Access Compliance Report

Public Rights-of-Way

Intersection ID: 10035599	Main Street: REAMES_RD	Cross Street: N/A	Location: E
ADA ID: 2309DE852836	Ramp Type: Perp	Initial Pass/Fail: Pass	Overall Compliance: No
		Severity Score: 0.25

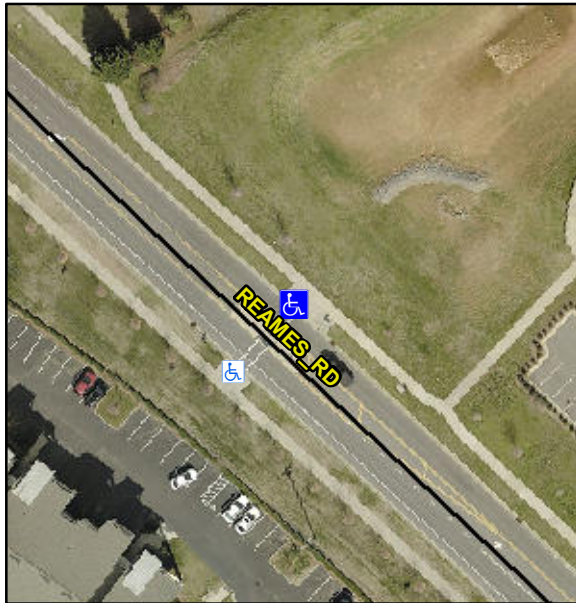
Not Found, R304.5.3, R305.2

Remove & Replace Entire Ramp.
